The Great Grid Upgrade

Norwich to Tilbury

2023 Non-Statutory Consultation Feedback Report

AENC-NG-CNS-REP-0007

Figure 4.11 - South Norfolk section map

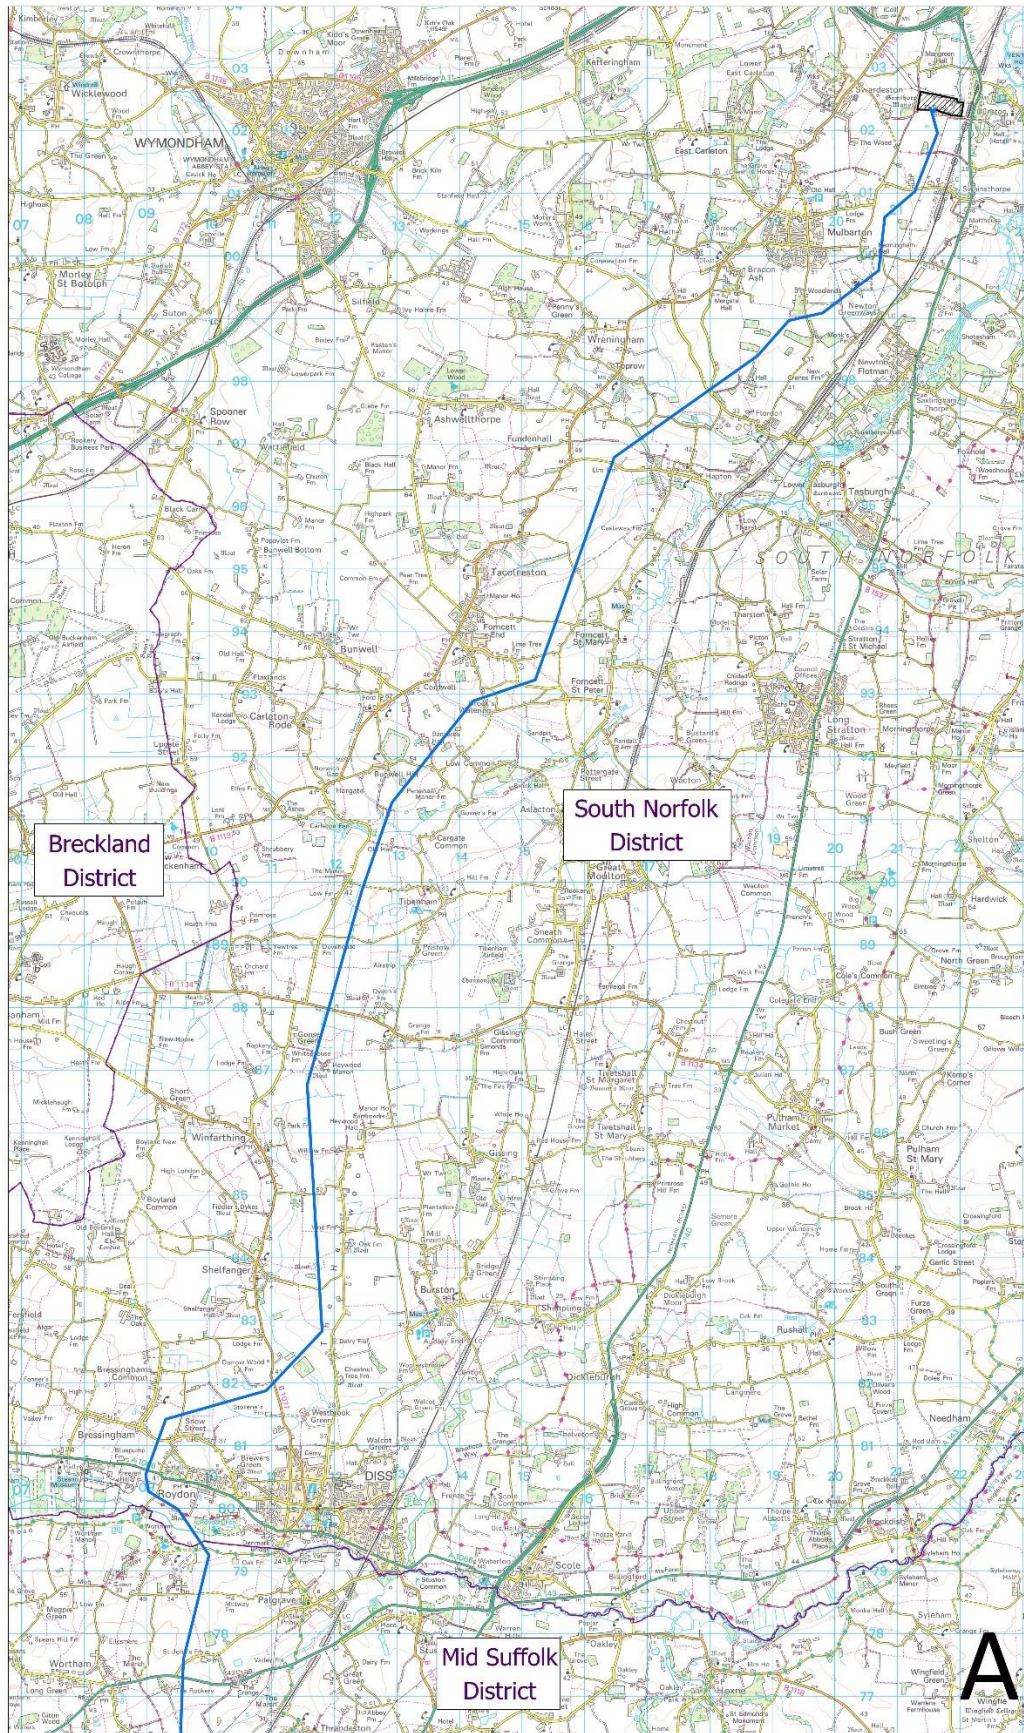
Ref no.	Summary of matters raised	National Grid's response
Agricultural Land		
4.3.1	Concern that the Project will take away valuable agricultural land / disrupt farming operations.	National Grid is and will continue to work with all landowners including farmers who may be affected by the proposals to understand the impacts on their operations and to work with them as the Project is developed. We will seek to work with the farming community to limit disruption where practicable. This includes providing prior warning of works which may result in the need to move livestock. Compensation claims for disturbance are considered on a case-by-case basis, if negative impact on farming operations can be proven. Particular agricultural matters can also be addressed through voluntary land agreements.
Airfields

Figure 4.12- Mid Suffolk section map

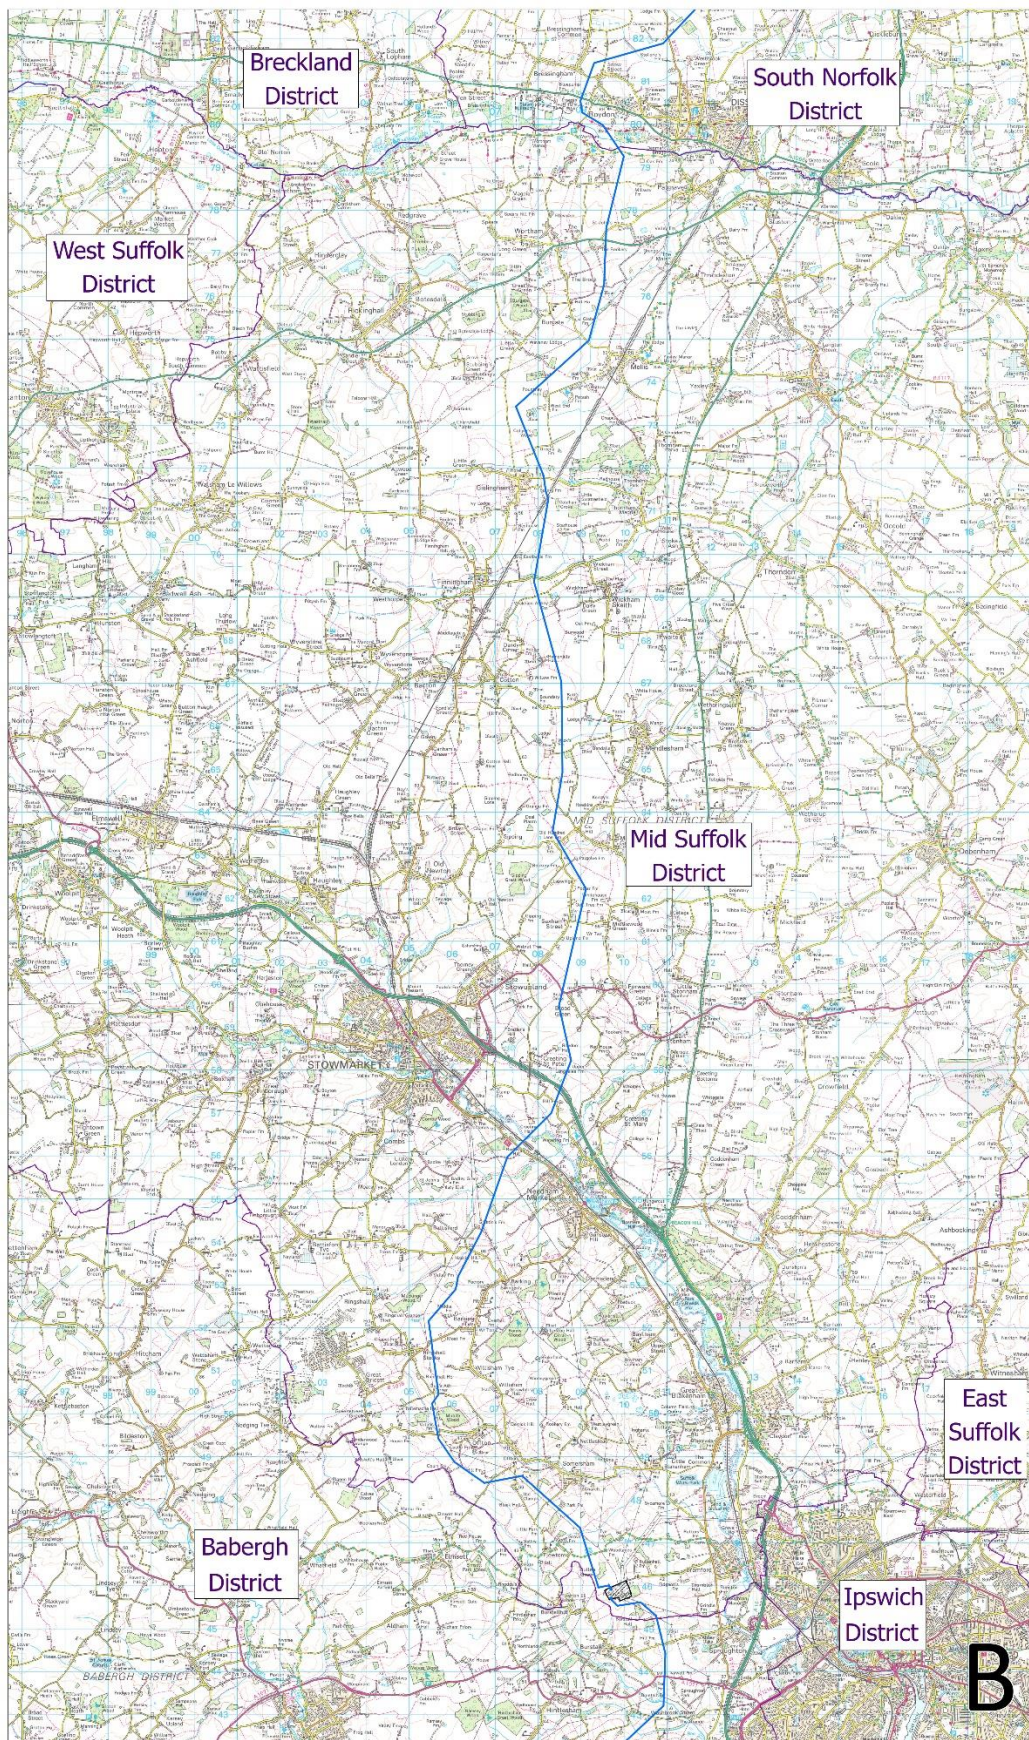
Ref no.	Summary of matters raised	National Grid's response
Agricultural Land		
4.4.1	Concern about the impact of the Project on drainage (for agricultural land).	Drainage surveys will be carried out in advance of construction works and will include on-site assessments and engagement with affected landowners. Existing drainage will be avoided where reasonably practicable. Where it cannot be avoided, it will be rerouted or temporary drainage will be installed for the construction period.

Figure 4.13- Babergh, Tendring and Colchester section map

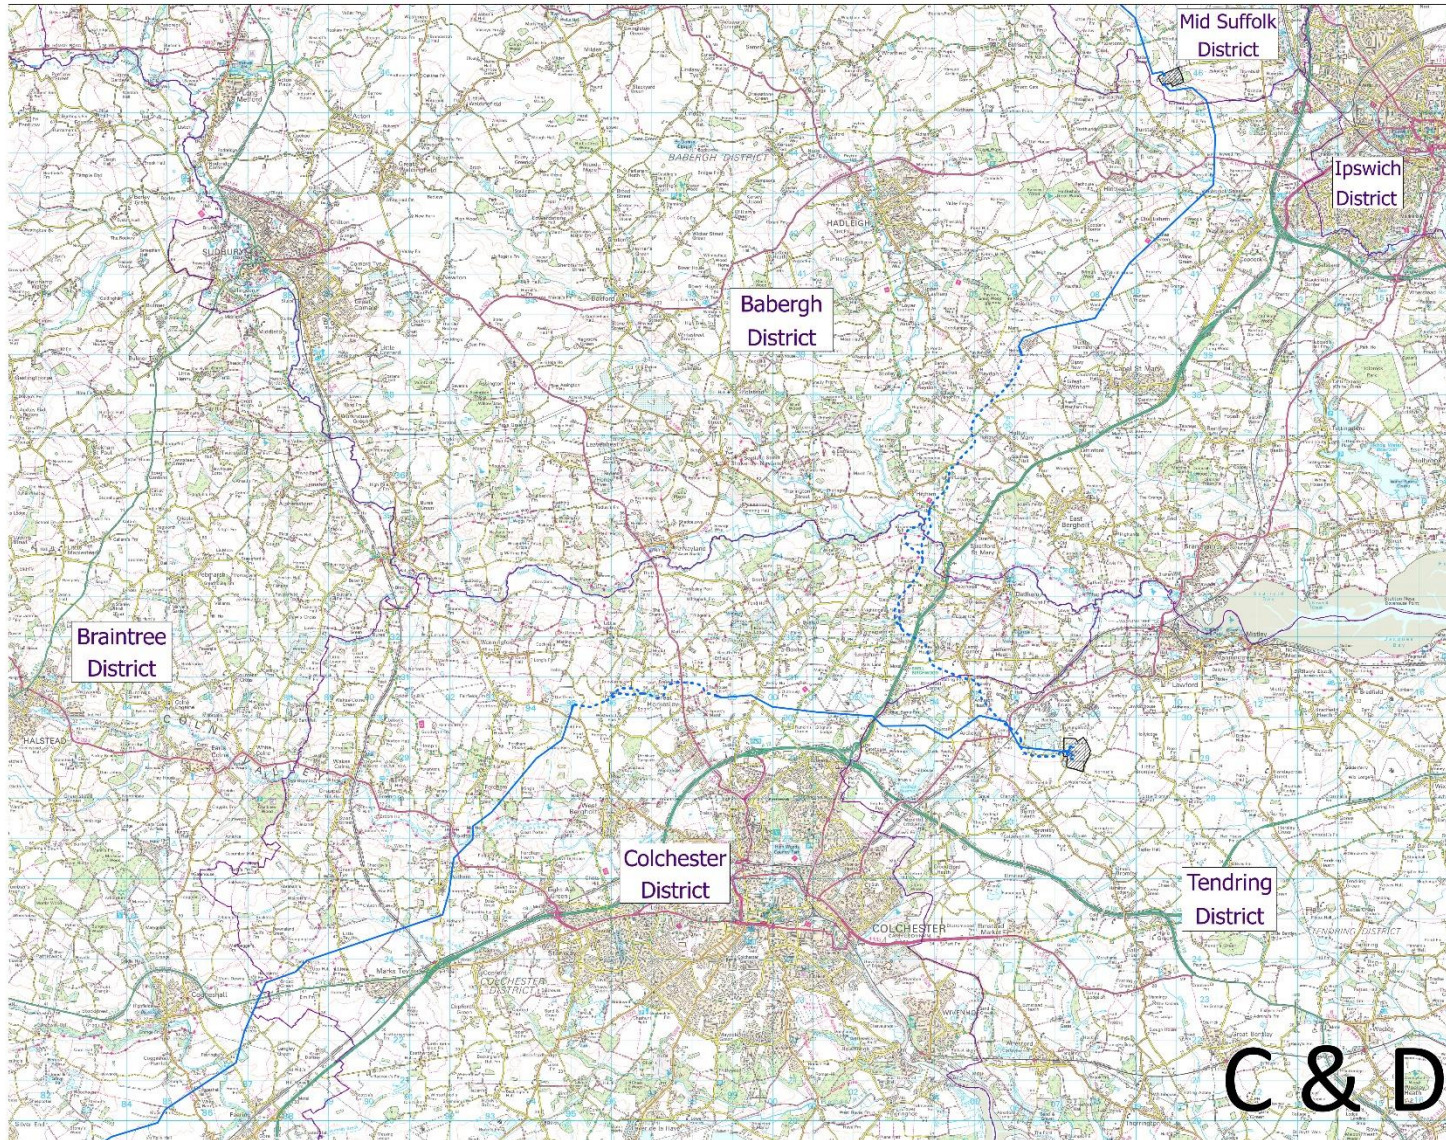
Ref no.	Summary of matters raised	National Grid's response
Agricultural Land		
4.5.1	Concern that the Project will take away valuable agricultural land / disrupt farming operations.	National Grid is and will continue to work with all landowners including farmers who may be affected by the proposals to understand the impacts on their operations and to work with them as the Project is developed. We will seek to work with the farming community to limit disruption where practicable. This includes providing prior warning of works which may result in the need to move livestock. Compensation claims for disturbance are considered on a case-by-case basis, if negative impact on farming operations can be proven. Particular agricultural matters can also be addressed through voluntary land agreements.

Figure 4.14- Braintree section map

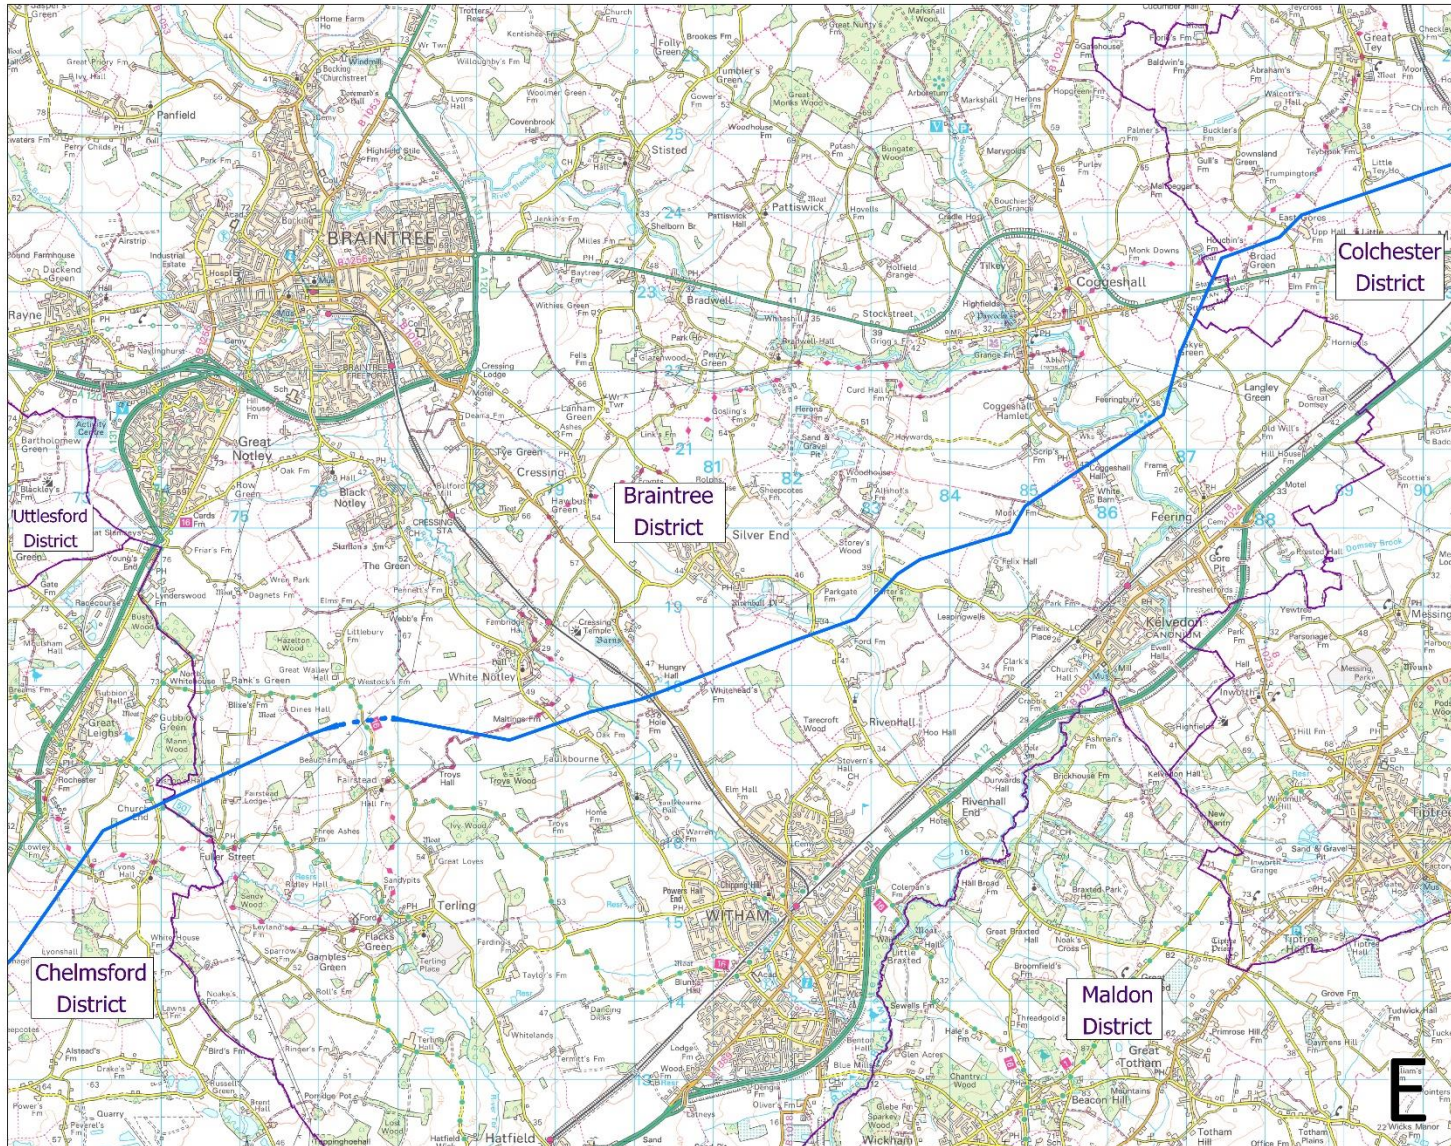
Ref no.	Summary of matters raised	National Grid's response
Airfields		
4.6.1	Concern about the impact of the Project on Barnards Farm Airstrip / West Horndon Airfield / Suggestion that the Project is routed away from West Horndon Airfield.	National Grid has appointed an independent aviation consultancy which has engaged with (with National Grid also present) Barnards Farm airstrip located in West Horndon. Following discussion and further assessment, it has been determined, with the Project as currently proposed, that the airfield can continue to operate. We will continue to engage with nearby airfields as appropriate throughout the project development process.

Figure 4.15 Chelmsford section map

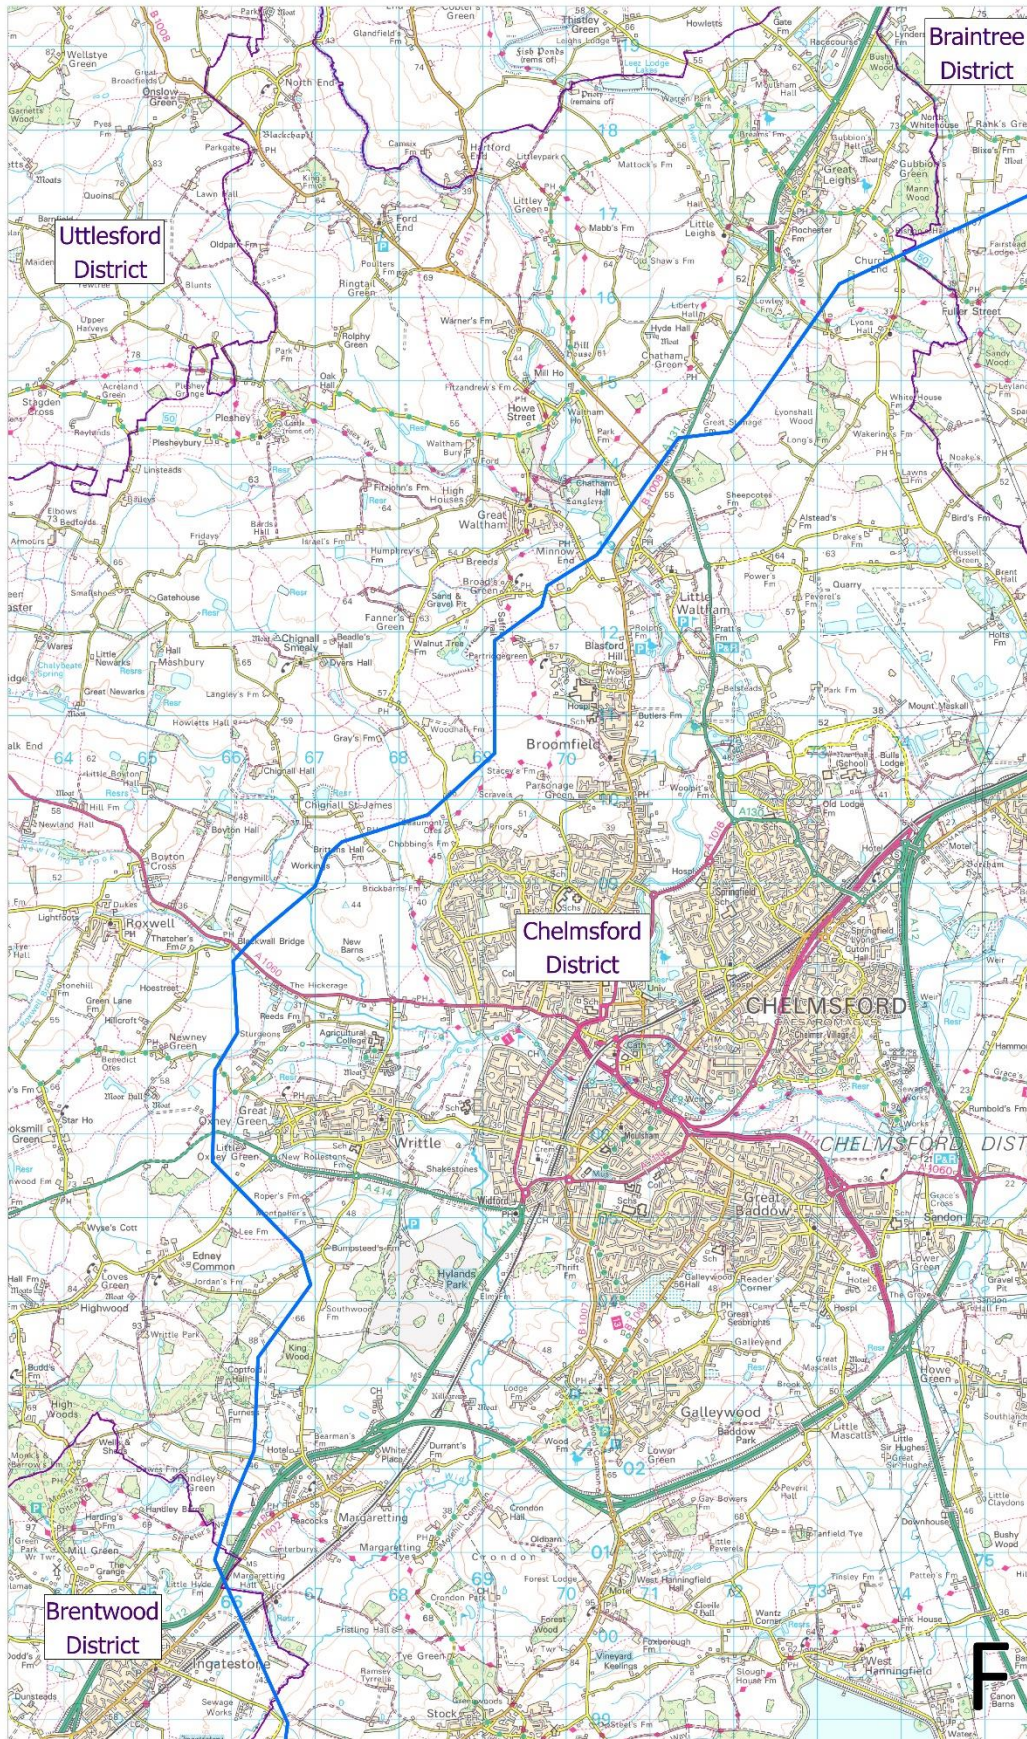
Ref no.	Summary of matters raised	National Grid's response
Agricultural Land		
4.7.1	Concern that the Project will take away valuable agricultural land / disrupt farming operations.	National Grid is and will continue to work with all landowners including farmers who may be affected by the proposals to understand the impacts on their operations and to work with them as the Project is developed. We will seek to work with the farming community to limit disruption where practicable. This includes providing prior warning of works which may result in the need to move livestock. Compensation claims for disturbance are considered on a case-by-case basis, if negative impact on farming operations can be proven. Particular agricultural matters can also be addressed through voluntary land agreements.
Airfields

Figure 4.16- Basildon and Brentwood (and Chelmsford east of Ingatestone) section map

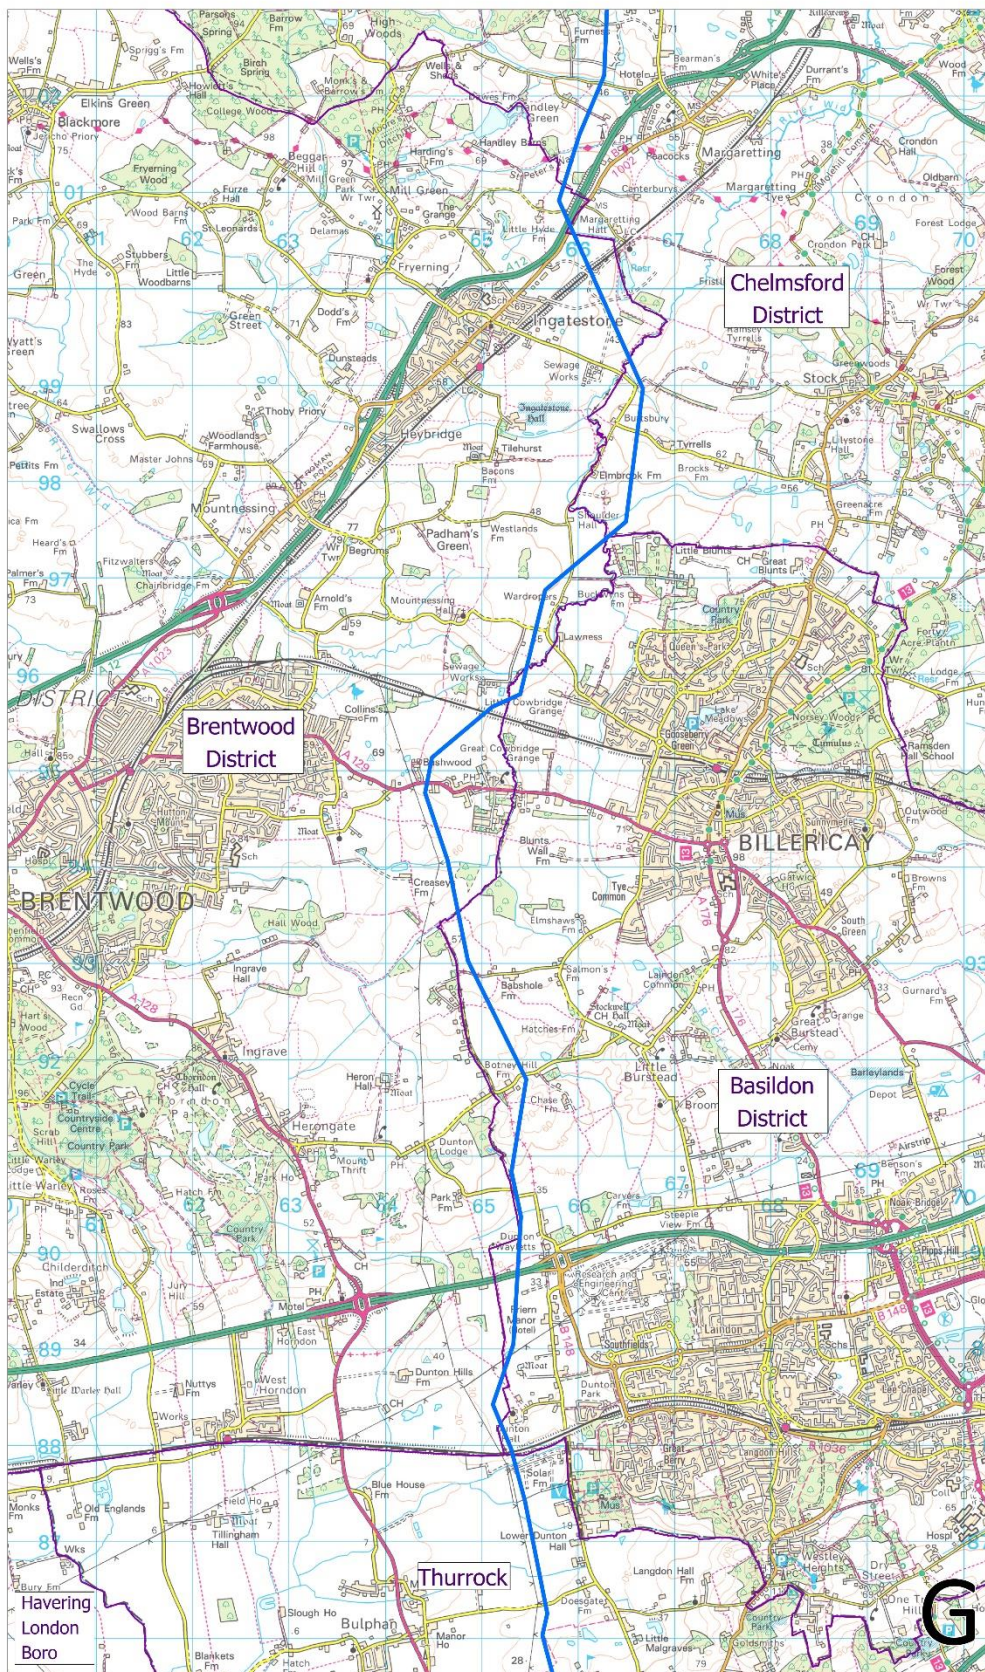
Ref no.	Summary of matters raised	National Grid's response
Agricultural Land		
4.8.1	Concern that the Project will take away valuable agricultural land / disrupt farming operations.	National Grid is and will continue to work with all landowners including farmers who may be affected by the proposals to understand the impacts on their operations and to work with them as the Project is developed. We will seek to work with the farming community to limit disruption where practicable. This includes providing prior warning of works which may result in the need to move livestock. Compensation claims for disturbance are considered on a case-by-case basis, if negative impact on farming operations can be proven. Particular agricultural matters can also be addressed through voluntary land agreements.
Airfields
